STAFF REPORT
(Revised Final Plat, Overall Preliminary Plat Approved 1/16/03)

CASE NUMBER: SUB 2003-149 -- AVALON PARK THIRD ADDITION

SUB 2003-149 -- Final Plat of AVALON PARK THIRD ADDITION

ITEM NO. 3: SUB 2003-149 -- AVALON PARK THIRD ADDITION

AVALON

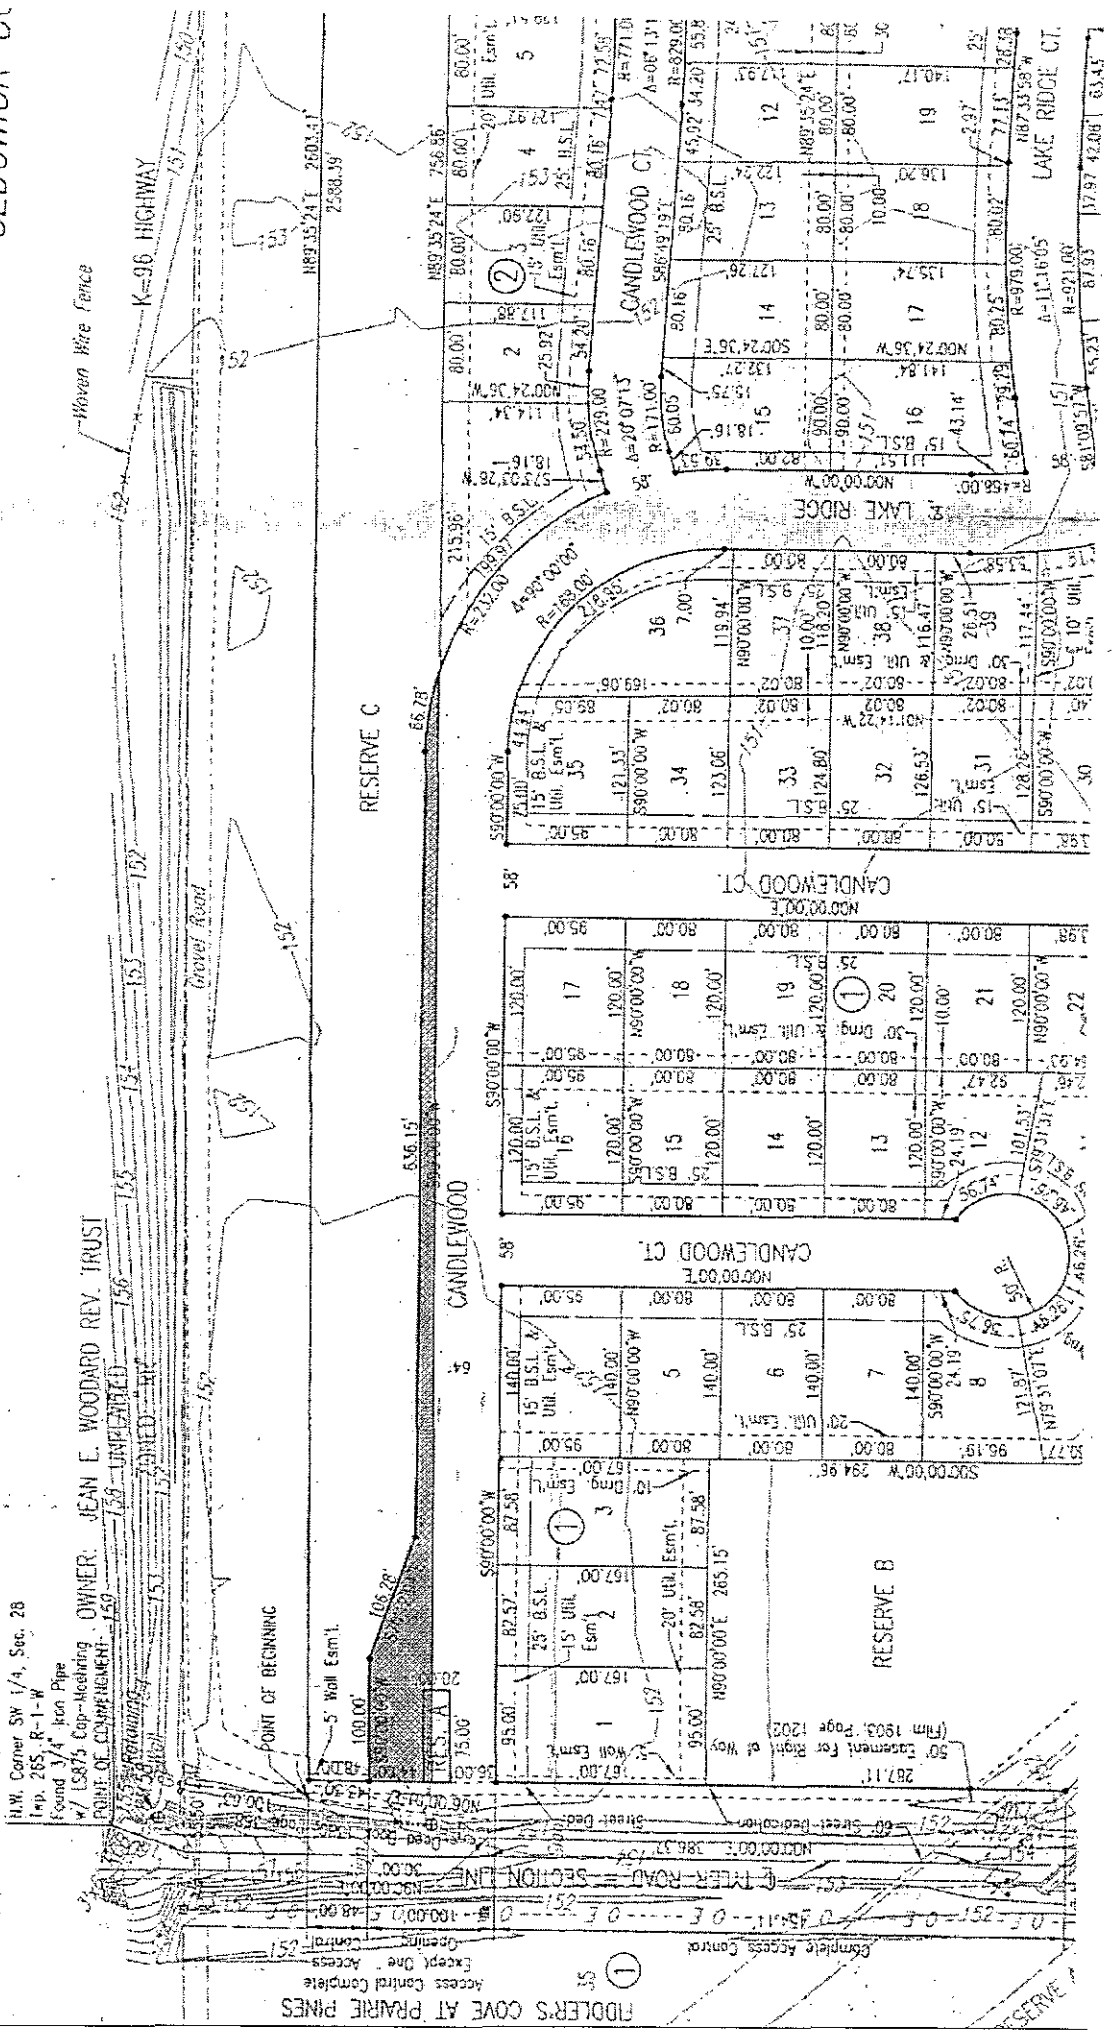
Thank you for allowing us the opportunity to review the plat for Avalon Park 3rd Addition. I do have a couple of comments that I would like to share with you concerning the proposed plat.

1. I recommend that the connection of Candlewood to Tyler Rd. be located as far to the south as possible in order to lessen any impacts of a possible grade change on Tyler Rd. If, for any reason, it becomes necessary to replace the Tyler Rd. bridge over K-96, it would very likely result in a raise in the elevation of Tyler Rd. in the vicinity of the proposed Candlewood connection. The farther to the south this connection is located, the smaller the impact on Candlewood should the Tyler Rd. profile be raised.

2. KDOT has recently purchased the north 100' of the SW Quarter of Section 28 from Avalon Park, L.L.C. to accommodate the future construction of the NW Wichita Bypass tie-in to existing K-96. A condition of the warranty deed required the landowner(s) to provide a reserved "greenbelt" across the South 100' of the North 200' of Section 28. This area is designated as "Reserve C" on the proposed plat. While the proposed plat provides for this "greenbelt" across the easterly portion, it does not maintain the required 100' across the west portion of the area. The area of encroachment is shown in red in the attached file. KDOT has compensated the landowner(s) for the "greenbelt" area and it is essential that the entire 100' be dedicated as a "greenbelt" on the plat. The deed has been registered with Sedgwick County and a copy is available upon request.

If it is not too much trouble, I would like to be kept informed on the status of the plat and any changes that are made relative to my comments. Thanks again for the opportunity to comment and we look forward to continued cooperation with your office.
